**SUBDIVISION REVIEW SHEET****CASE NO.:** C8-2020-0037**COMMISSION DATE:** Apr. 20, 2021**SUBDIVISION NAME:** Marshall Ranch Preliminary Plan**AREA:** 37.23 ac.**LOT(S):** 54**OWNER:** Eanes Marshall Ranch, LP (Linda K. Haines)**AGENT/APPLICANT:** Jonathan Fleming (KT Civil)**ADDRESS OF SUBDIVISION:** 1300 Lost Creek Blvd    **COUNTY:** Travis**WATERSHED:** Eanes Creek & Barton Creek**JURISDICTION:** Full Purpose**COUNTY:** Travis**DISTRICT:** 8**ZONING:** SF-2**NEIGHBORHOOD PLAN:** N/A**PROPOSED LAND USE:** Single-family, and Open Space

**STAFF RECOMMENDATION:** Staff recommends approval with conditions based on the review comments in the attached Master Comment Report.

**CITY OF AUSTIN –DEVELOPMENT SERVICES DEPARTMENT  
SUBDIVISION APPLICATION – MASTER COMMENT REPORT**

PROJECT NAME: Marshall Ranch Preliminary Plan  
LOCATION: 1300 LOST CREEK BLVD

COVER SHEET

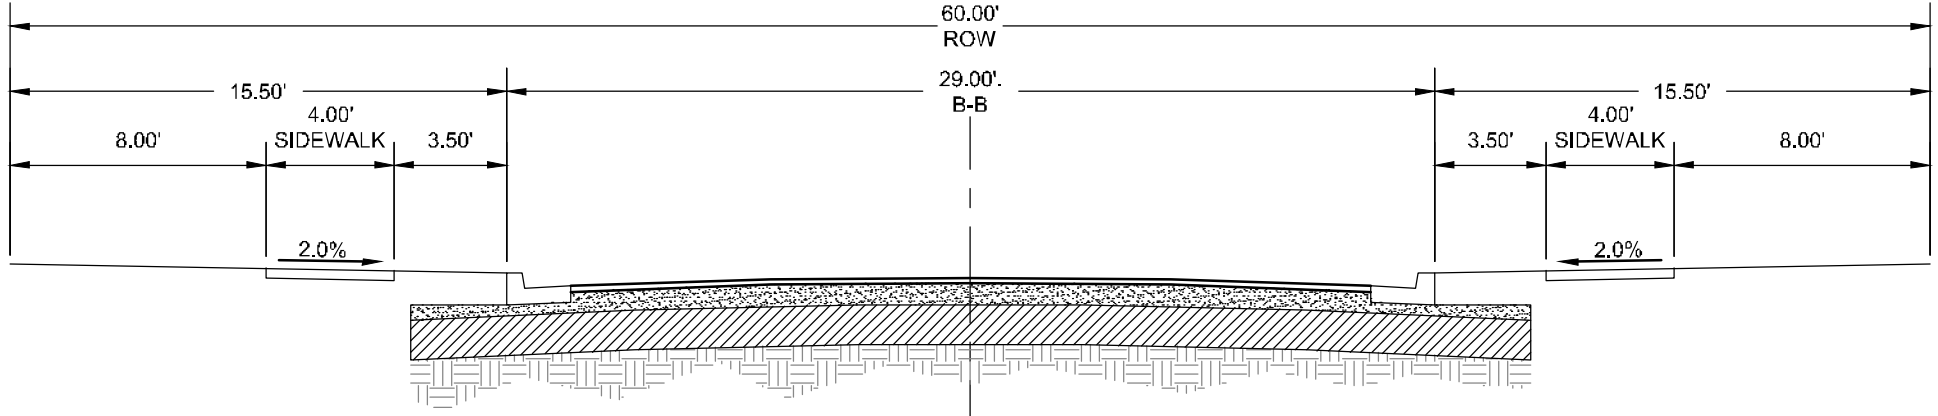
EV 9 Due to the revisions in this update, ensure coversheet note #29 includes all the lots and lot numbers that contain slopes greater than 15%. [LDC 25-8, Subchapter A, Article 7; ECM 1.8.0, 1.11.0]

**Please remove this note from the approval block as previously requested because it is already listed as plan note 10 and please make sure that Marshall Ranch Rd, Eternity Terrace and Eanes Homestead Rd are listed under section (A) in plan note 10.**
